MIL-M-28787/126A(SH)
AMENDMENT 2
19 July 1991
SUPERSEDING
AMENDMENT 1
14 November 1983

MODULES, STANDARD ELECTRONIC

LOAD, RESISTOR, STANDARD, ANALOG, KEY CODE FLB

FIGURE 4 Resistance and continuity test circuit for tables III and IV

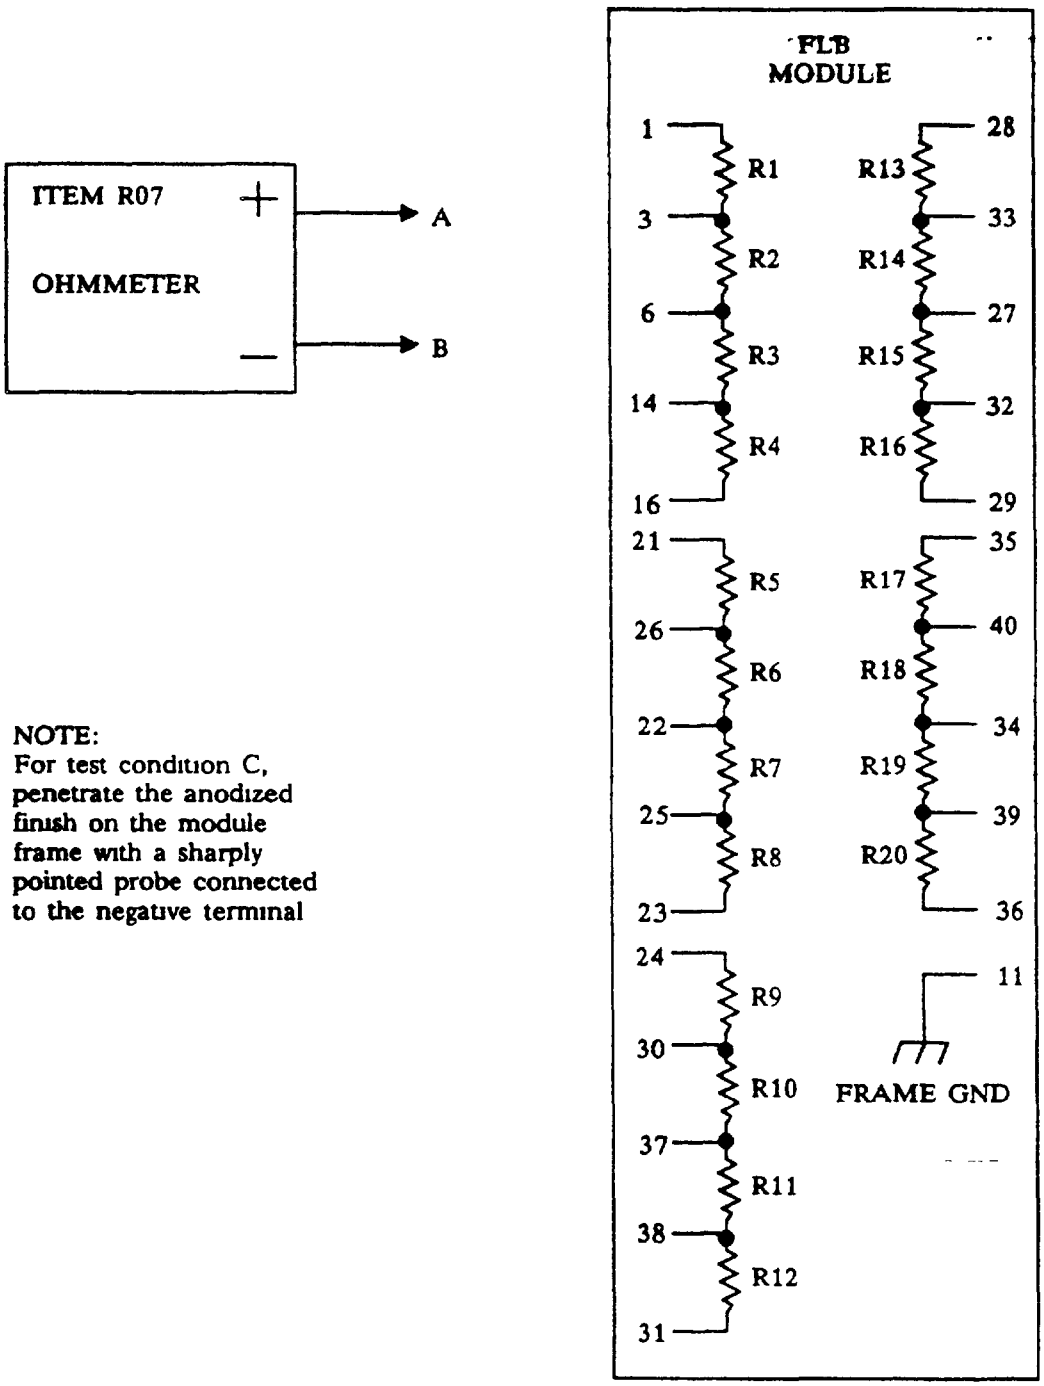
FIGURE 4: Delete and substitute new figure 4 as printed on page 4 of this amendment

NOTE:
For test condition C, penetrate the anodized finish on the module frame with a sharply pointed probe connected to the negative terminal
